**Goldfields Gas Transmission's Proposed
Access Arrangement for the Goldfields Gas Pipeline**

**Review of Technical Aspects of the
Proposed Access Arrangement (AA4)**

Report to

Economic Regulation Authority of Western Australia

Figure 5: GGP unit operating expenditure KPI (\$Sep 2018)

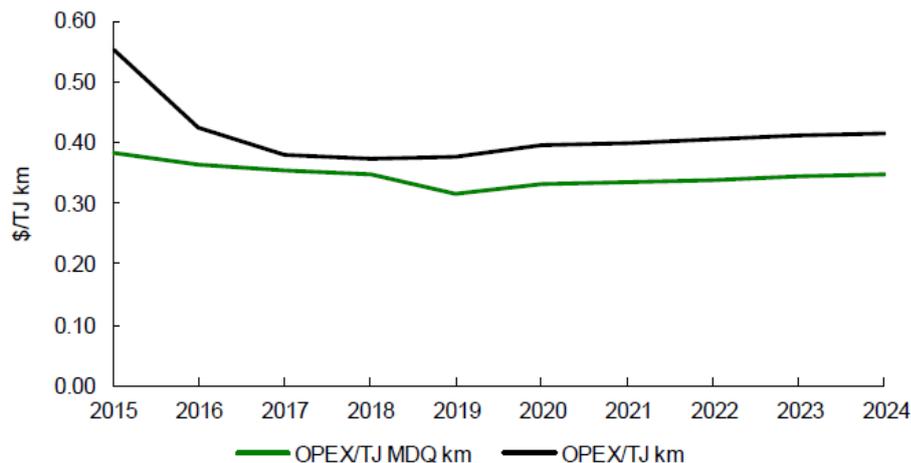
89. There are four other current regulated gas transmission submissions, each of which provide KPIs for opex per pipeline km and opex per mmkm. These KPIs are not able to be compared to GGT's KPIs.
90. We asked GGT to provide any available benchmarking information it had to support its AA4 Proposal in addition to the 'Solomon benchmarking report' we were advised GGT had (at our on-site meeting with GGT on 6 March 2019). In its response,¹⁸ GGT provided four graphs of aspects of 'Stay In Business' capex normalised for Equivalent Pipeline Complexity (EPC), a measure of asset complexity developed by Solomon Associates. The comparisons are between GGP and the APA Group (US & Canada and the Company average). The GGP compares very favourably on the four metrics

91. In accordance with the requirements of rule 72(1) of the NGR, GGT is required to include KPIs supporting the expenditure forecast for the next AA period.
92. GGT has provided opex KPIs which are intended to support its expenditure over the AA4 period. We believe this is a satisfactory KPI for this purpose. However, it does not provide an explicit basis for comparison with other regulated Australian gas transmission pipelines. We therefore recommend that the ERA requires GGT to present an opex KPI based on opex per pipeline km to facilitate comparison with other Australian gas transmission pipelines.

Figure 6: Comparison of actual AA3 capex with GGT forecasts and ERA allowance

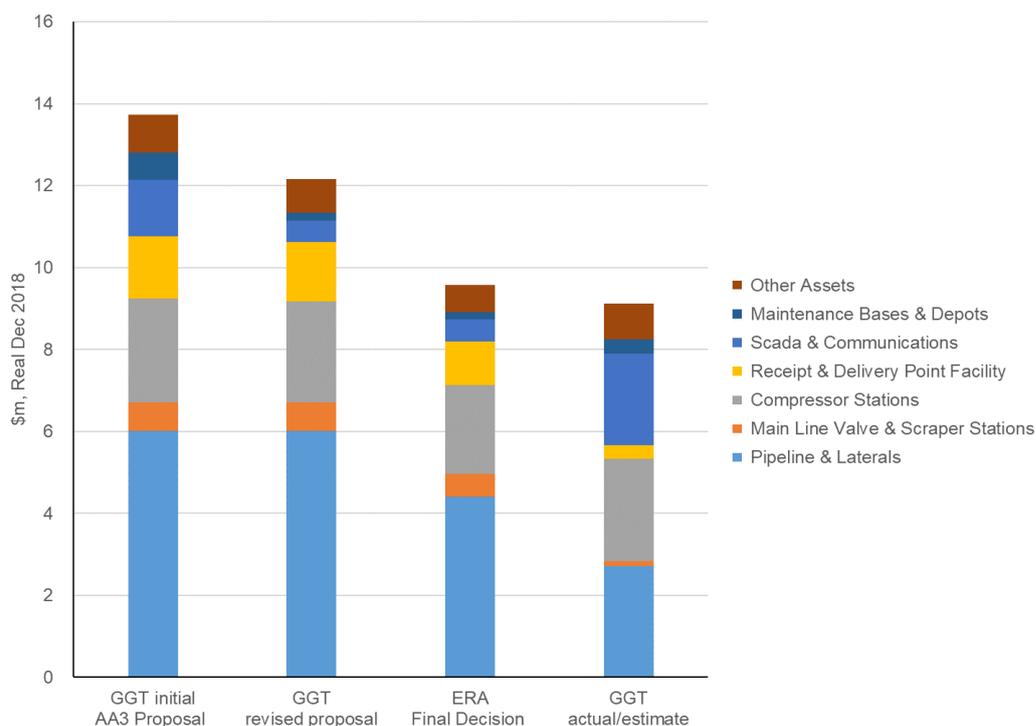
130. As shown in the table above, GGT underspent the \$6.01m capex that it forecast in its revised AA3 Proposal by \$3.45m or 57%, which is \$1.85m below the ERA allowance of \$4.41m. The reason for the negative adjustment for the GGT Gorgon Interconnect project was not explained.

Figure 7: GGT AA3 capex, ERA allowance and EMCa adjusted

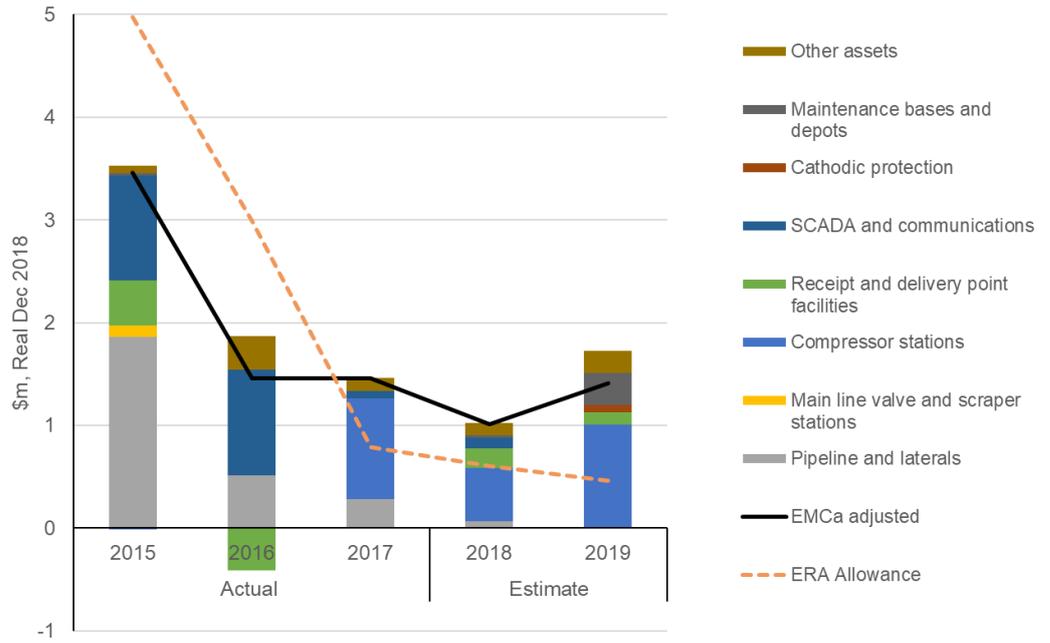
173. The following graph illustrates the effect of the assessed adjustments against GGT's proposed conforming AA3 capex.

Figure 8: GGT Proposed AA5 capex allowance and EMCa adjusted

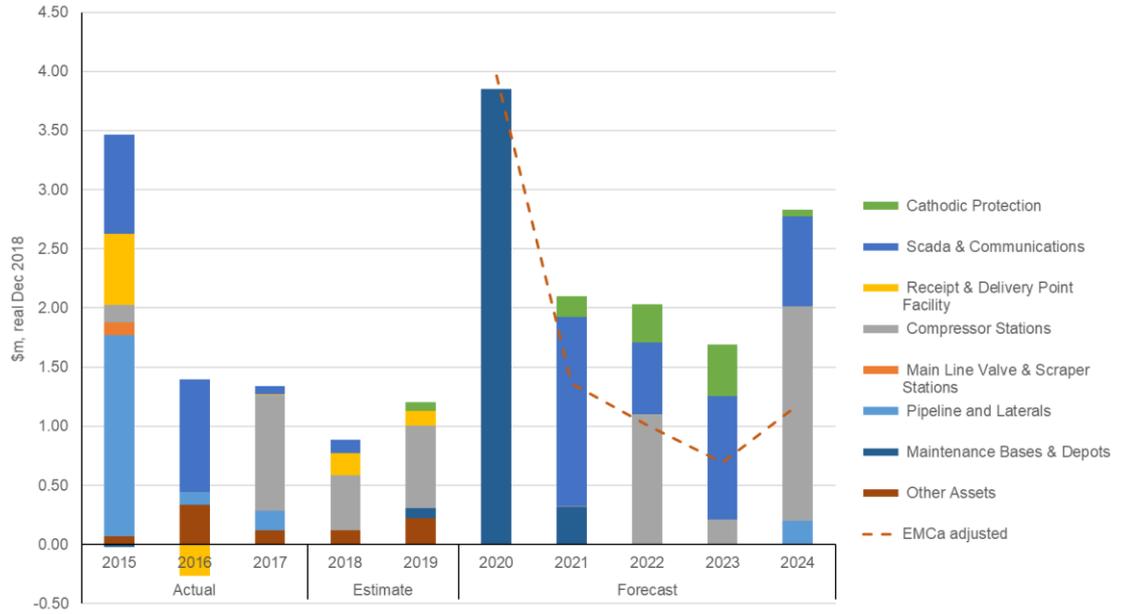
TOTAL						
GGT proposed	7.12	2.42	2.03	1.69	2.83	16.09
<i>less</i> EMCa projects/progrtam adjustment	-3.15	-1.05	-1.01	-1.00	-1.63	-7.85
<i>less</i> Labour escalation adjustment	0.00	-0.01	-0.01	-0.01	-0.02	-0.04
Total EMCa Adjusted	3.96	1.36	1.01	0.69	1.18	8.20
<i>Total adjustment (\$)</i>	-3.16	-1.06	-1.02	-1.00	-1.65	-7.89
<i>Total adjustment (%)</i>	-44%	-44%	-50%	-59%	-58%	-49%

Figure 9: GGT AA3 actual/estimate and AA4 proposed opex

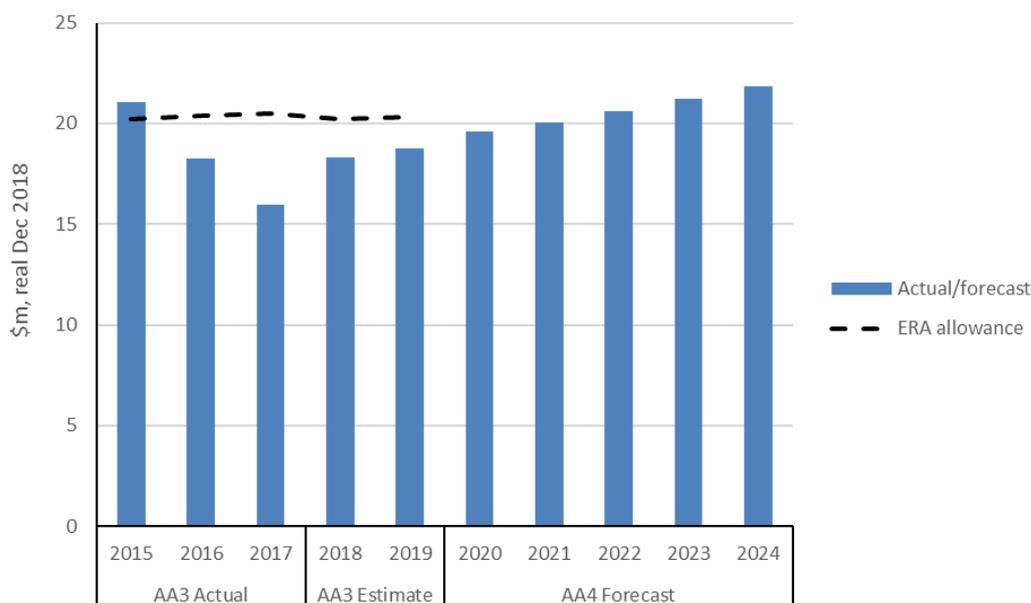
252. In real terms, GGT has proposed \$2.29m (69%) higher expenditure on Regulatory Costs, and \$1.00m more on Major Expenditure Jobs. While GGT’s proposed expenditure on Pipeline Operations and Commercial Operations is \$1.37m less (in real terms) than for AA3, care needs to be taken with interpreting this as our inspection of GGT’s workings shows that these two category figures result from GGT having applied an allocation process to its overall opex forecast.

253. The following graph illustrates how GGT’s annual opex has reduced through to 2017, which is the most recent year’s ‘actual’ costs provided. GGT has estimated an increase from its 2017 expenditure in the remaining two years of AA3, with a further upward trend proposed for AA4.
